Technical Service Bulletin

Subject: CHECK ENGINE LIGHT ON WITH DTC P0126:00	Bulletin No.: 01-011/21
	Last Issued : 09/27/2021

Replacement parts locations

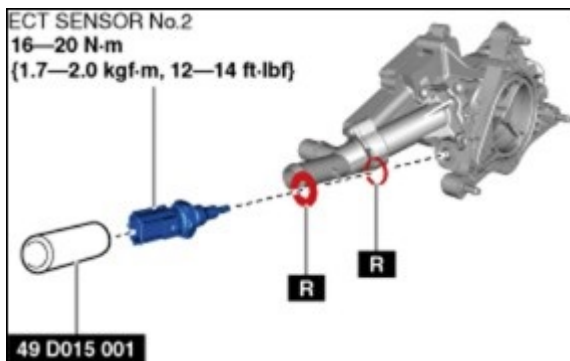
- O-ring
- Gasket
- Connector

- O-ring and washer for ECT sensor No.2
